Date: May 5, 2020 File: 2018-3181-00E-3.00

Project: CRSWSC Master Plan

Subject: CRSWSC Master Plan - Scenario 5 Update

Figure 11.9 - Cash Flow - Scenario 5

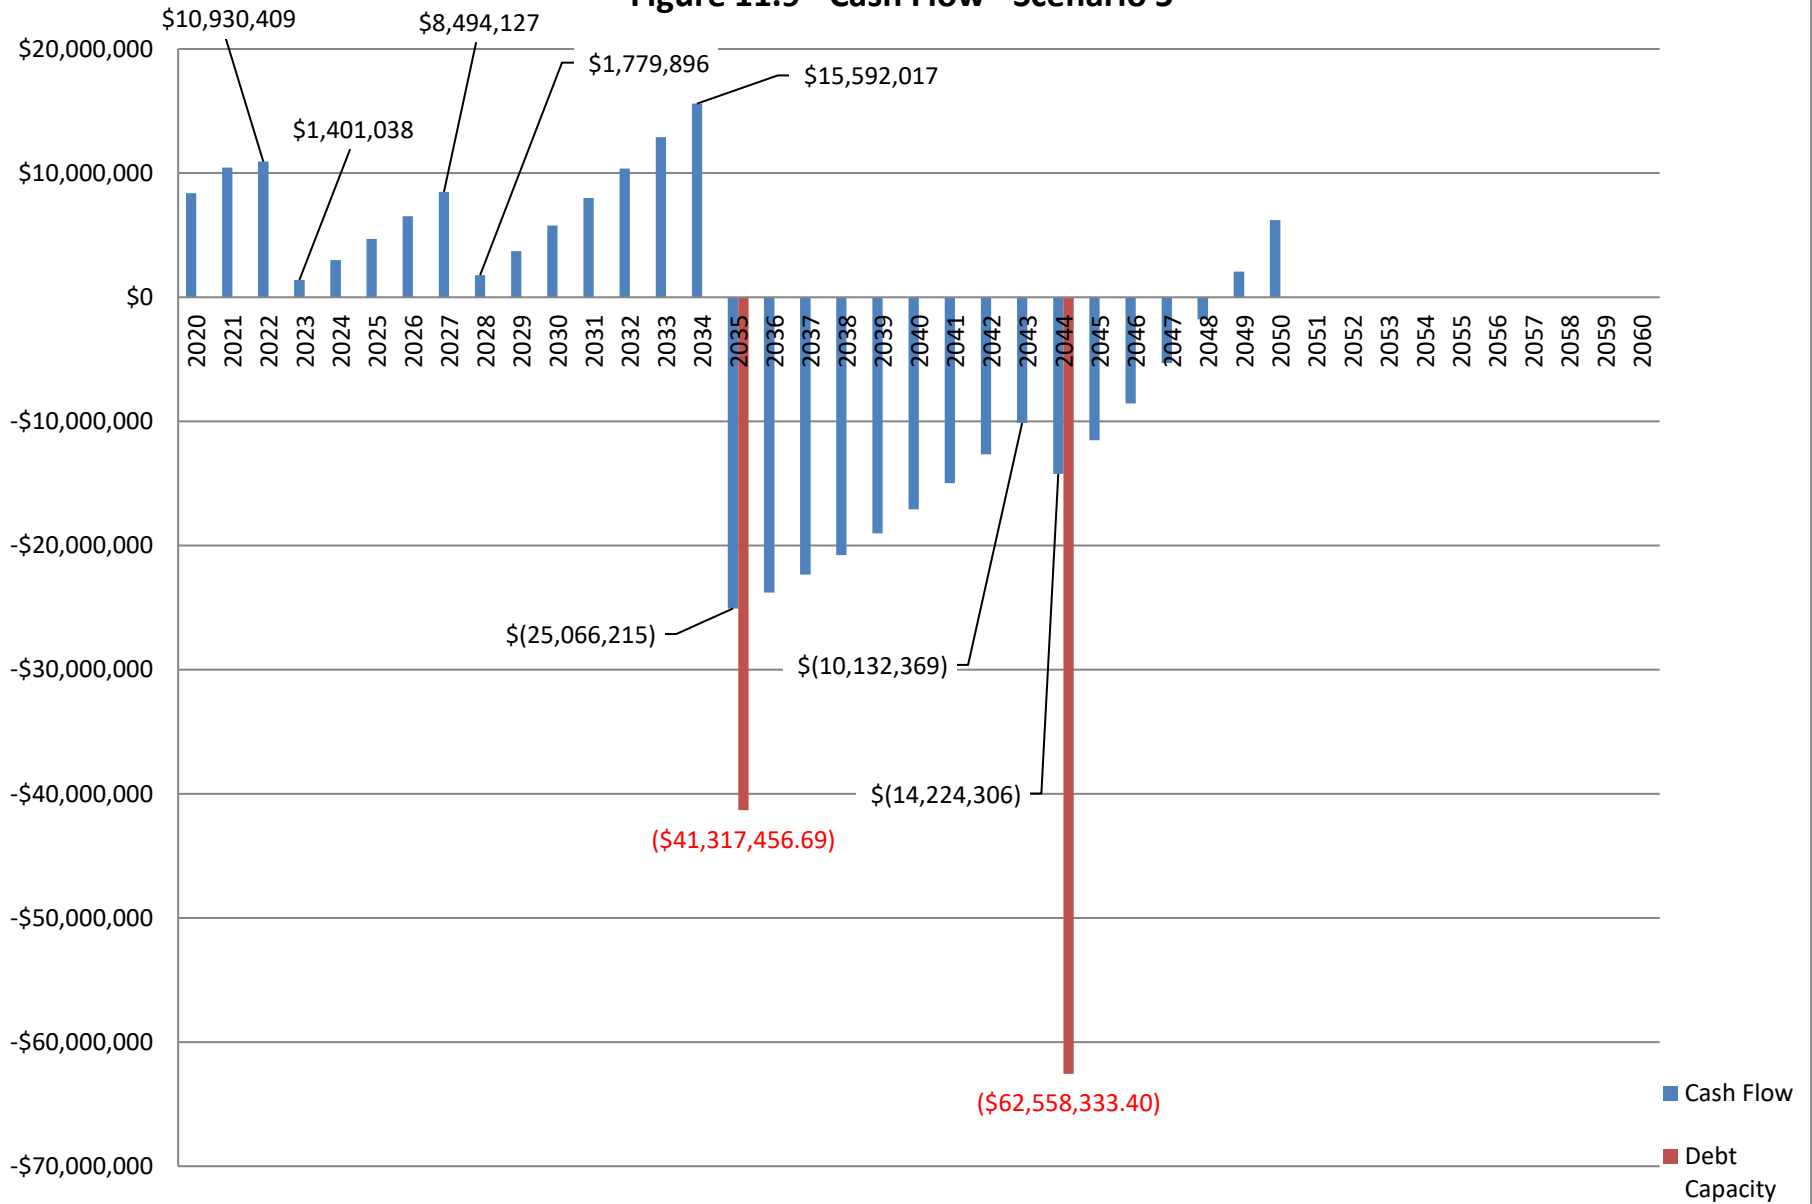
Based on this Scenario, the Commission would use its accumulated cash reserve of \$15.1M and a debenture of \$25.6M in 2035 to complete future capital expenditures. The debenture capacity of the Commission in 2035 is approximately \$41.3M. The debenture of \$25.1M taken in 2035 is approximately 61% of the Commission’s debenture capacity. In 2044 the Commission would take an additional debt of \$4.1M, for a combined debenture of \$14.2M. The additional debenture undertaken in 2044 is approximately 23% of the Commission’s debenture capacity. The Commission would pay back its accumulated debt by 2049.

This updated scenario assumes that the Commission started with an initial capital reserve of approximately \$6.0M in 2020. The Water Master Plan, assumed that the capital reserve of \$6M started in 2019. The impact of this change is outlined below:

- In 2035 the Commission’s anticipated debenture increases from \$21.3M to \$25.1M.
- In 2044 the Commission combined debt increases from \$8.7M to \$14.2M.
- The Commission pays its debt in 2049 instead of 2047 as originally forecasted.

Figures 11.9 and 11.10 have been updated to reflect the above changes.

Figure 11.10 - Unit Cost Analysis - Scenario 5

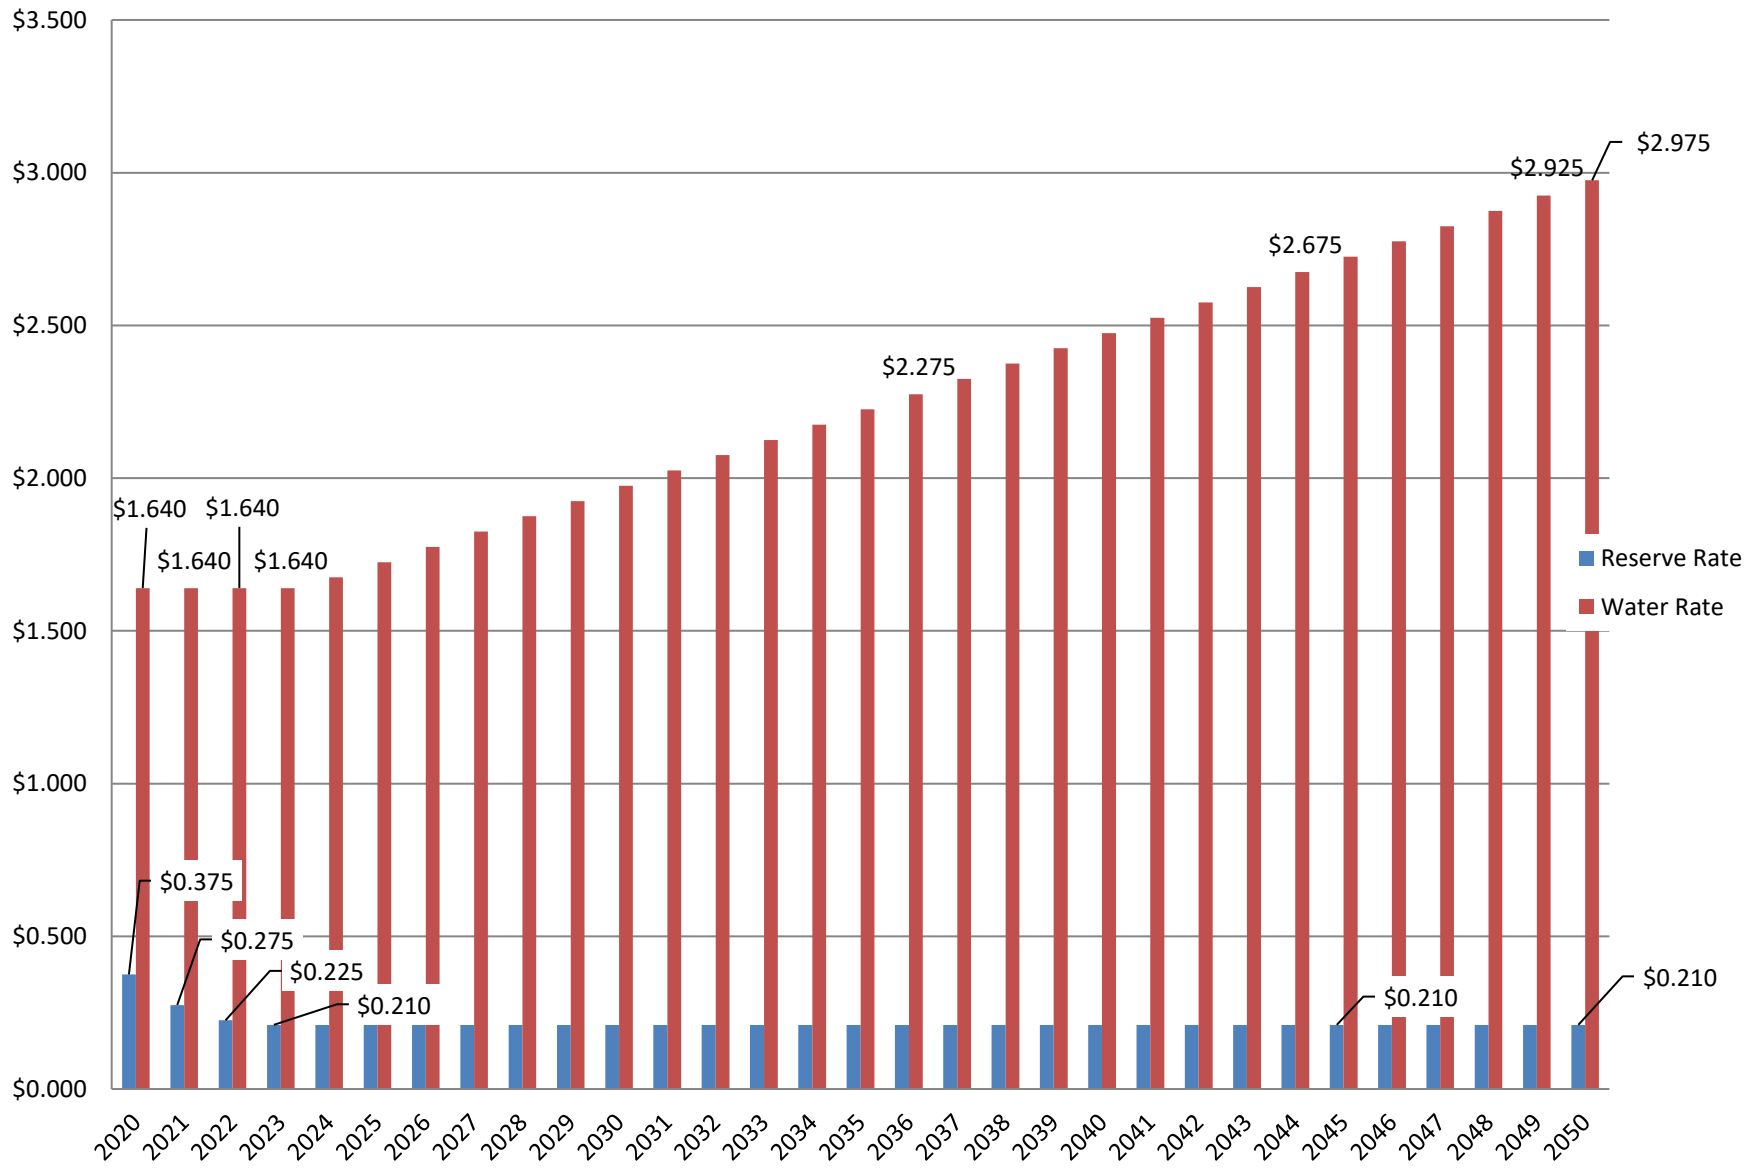
This Scenario is similar to Scenario 4, except the current water rate of \$1.64/m³ (2020) is used and held until 2023, and assumes the following:

- The Commission uses a combination of accumulated cash reserve and debt to undertake future capital expenditures.
- The Commission’s initial capital reserve is approximately \$6.0M in 2020.
- The Commission would reduce the current water reserve rate from \$0.375/m³ to \$0.21/m³ over the next three years.
